METROPOLITAN GOVERNMENT OF NASHVILLE AND DAVIDSON COUNTY

Metropolitan Historic Zoning Commission
Sunnyside in Sevier Park
3000 Granny White Pike
Nashville, Tennessee 37204
Telephone: (615) 862-7970
Fax: (615) 862-7974

STAFF RECOMMENDATION
3705 Richland Avenue
February 20, 2013

Application: New Construction – Addition and Accessory Structure; Setback reduction
District: Richland-West End Neighborhood Conservation Zoning Overlay
Council District: 24
Map and Parcel Number: 10409012100
Applicant: John Abernathy
Project Lead: Melissa Baldock, melissa.baldock@yahoo.com

Figure 7. The existing driveway

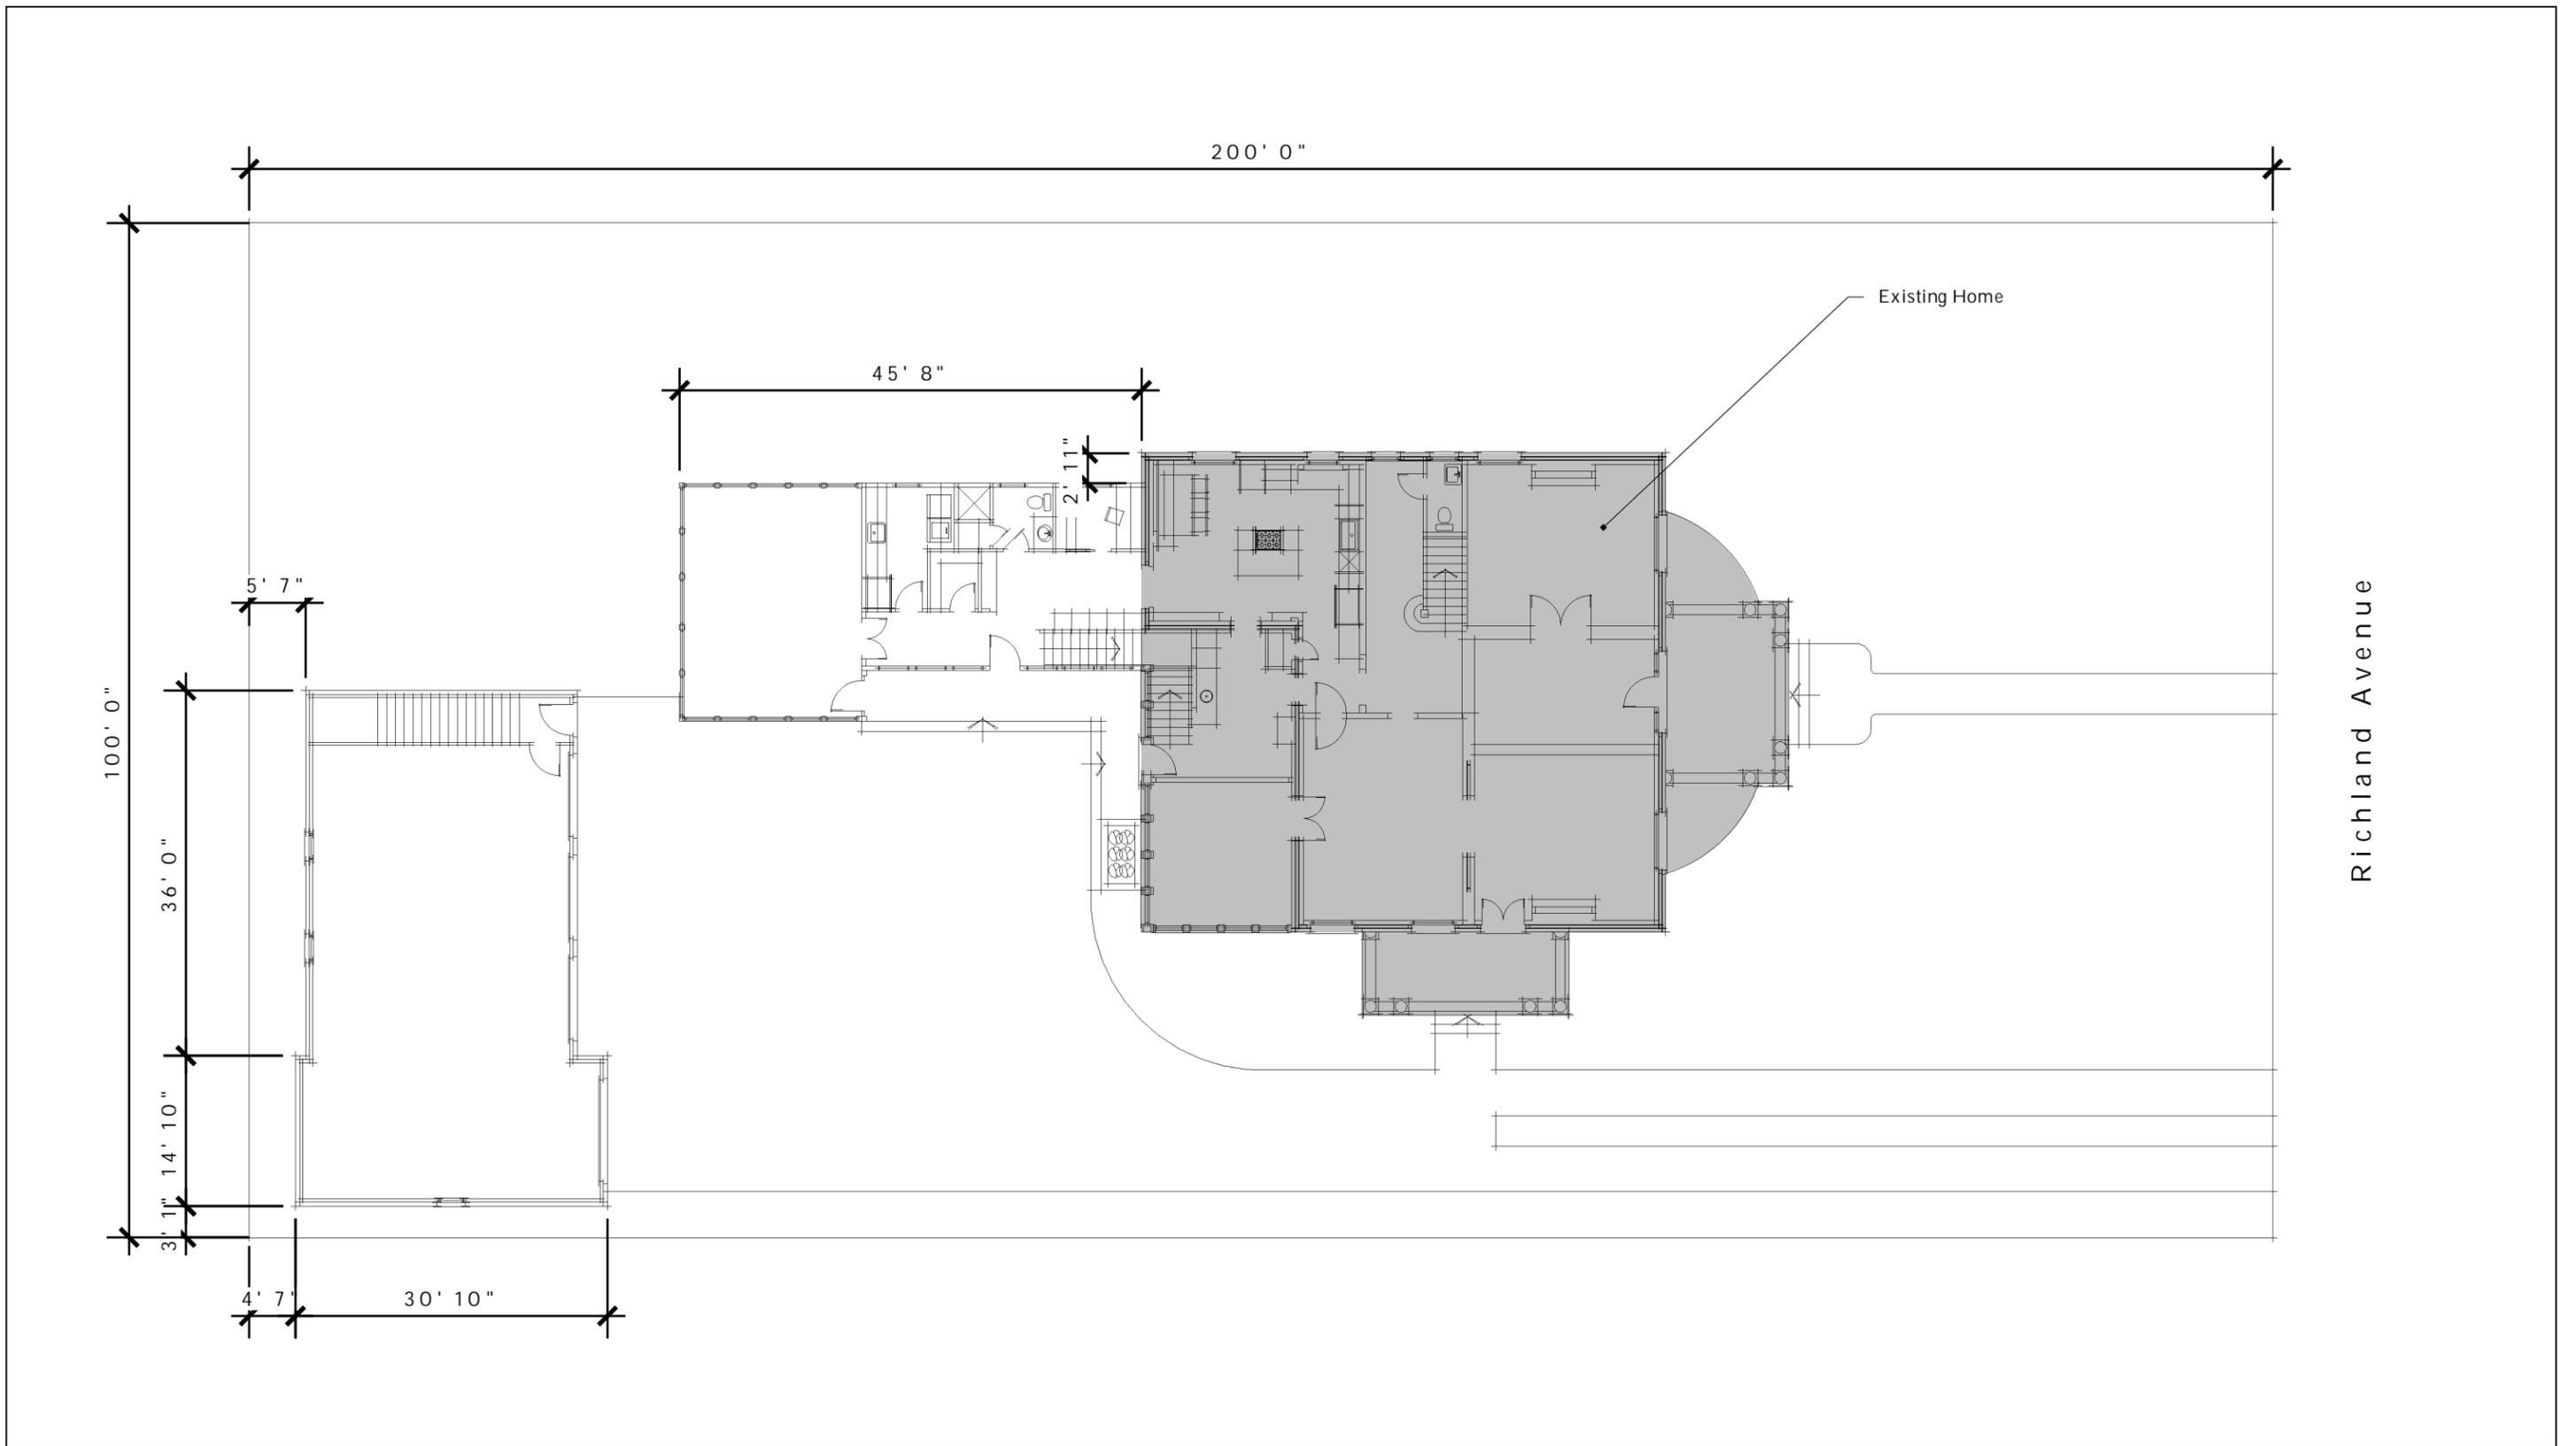
Accessory Structure: The accessory structure is proposed to be located behind the historic house in the rear yard, which was used for parking until recently (see Figures 4 & 5). It will be located four feet, seven inches (4'7") from the rear property line at its closest point and three feet, one inch (3'1") from the left side property line. Base zoning requires that accessory structures that are more than seven hundred square feet (700 sq. ft.) be twenty feet (20') from the rear property line and five feet (5') from the side property lines. The accessory structure therefore requires a setback reduction for the side and rear property lines. Staff finds that a setback reduction is appropriate because the structure will be located where accessory structures were historically located, and because many other existing accessory structures in the district are less than five feet (5') from the side property line and twenty feet (20') from the rear property line. In addition, the accessory structure will be situated at the back, left corner of the lot, away from the historic single-family neighborhood (see Figure 6). The garage will be accessed via an existing curb cut and will have garage doors facing the house (see Figure 7).

FRONT & REAR ELEVATIONS

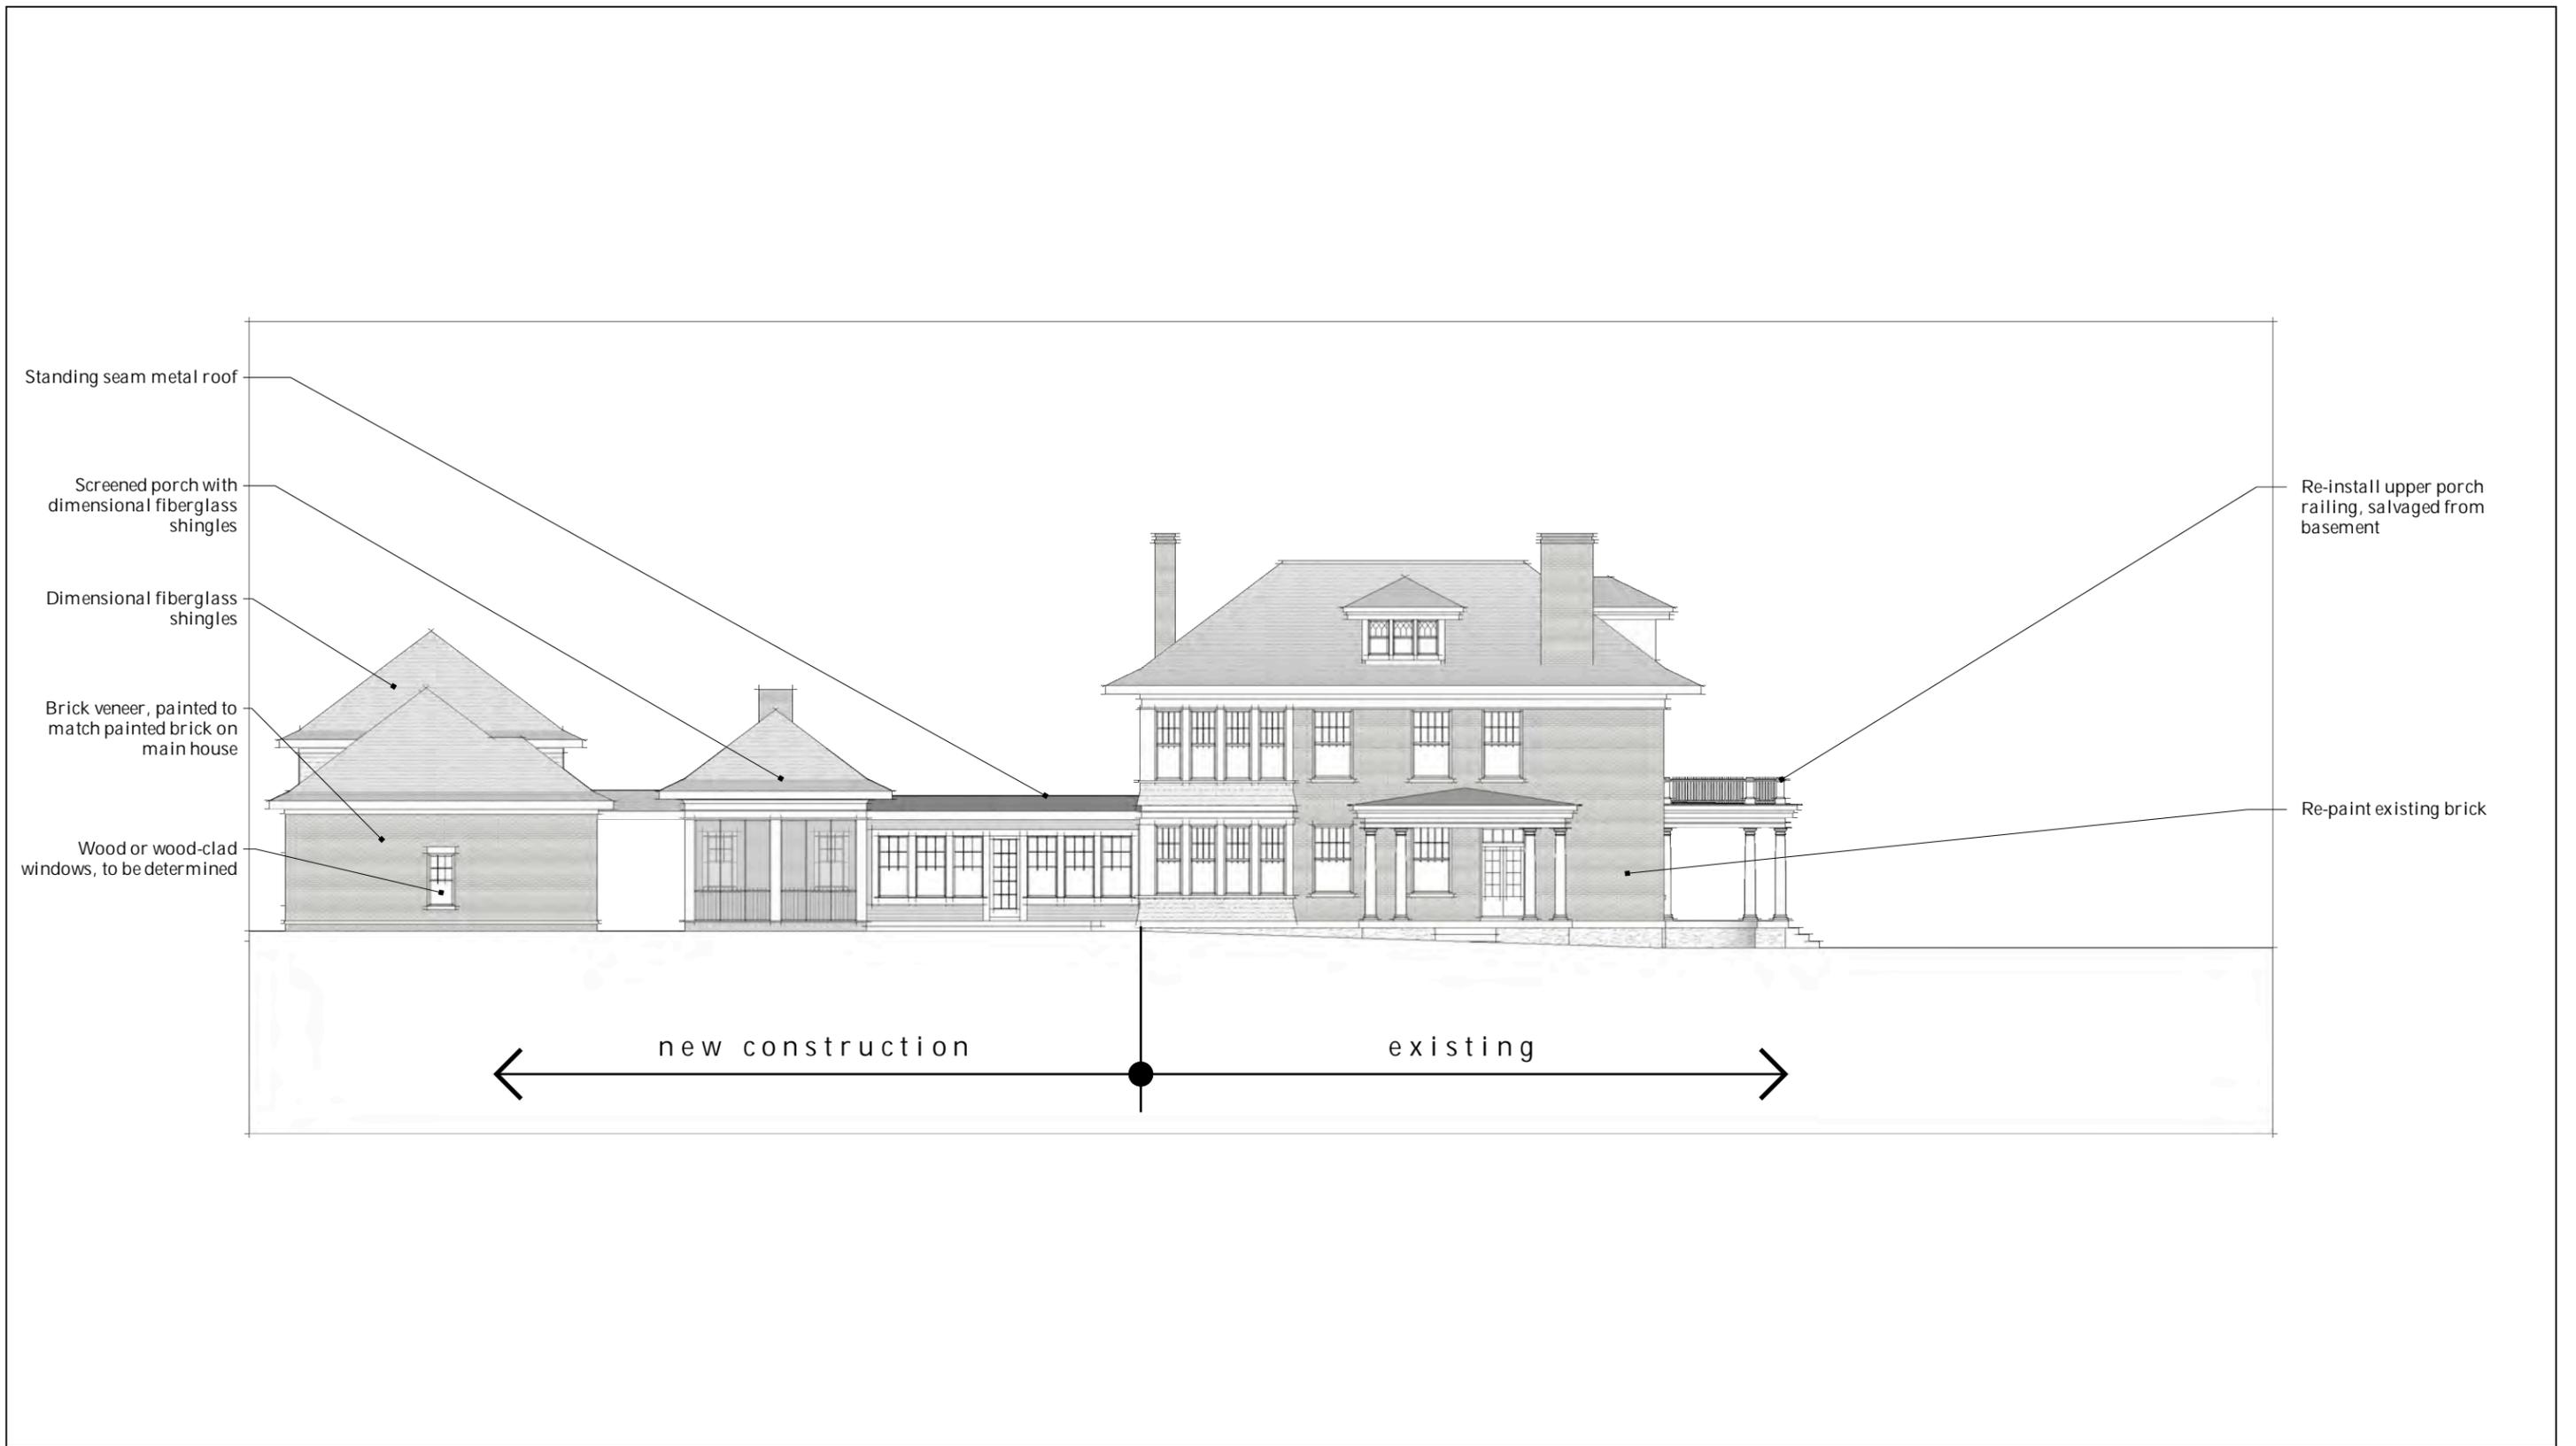
Roof Form: The existing house's primary roof form is a hipped roof with a slope of approximately 9/12. The addition will have two different roof forms. The portion of the addition that attaches to the house will have a low-sloped gable roof. The porch portion of the addition will have a hipped roof with a slope of approximately 9/12. Staff finds that the roof form is compatible with that of the house and with surrounding historic structures, and meets Sections II.B.1.e. and II.B.2. of the design guidelines.

Proportion and Rhythm of Openings: The drawings indicate that the window and door openings on the existing structure will not be altered as part of this project. The windows on the addition are twice as tall as they are wide, and there are no large expanses of wall space without a door or window opening. Staff finds that the addition's proportion and rhythm of openings meet Section II.B.1.g. and II.B.2. of the design guidelines.
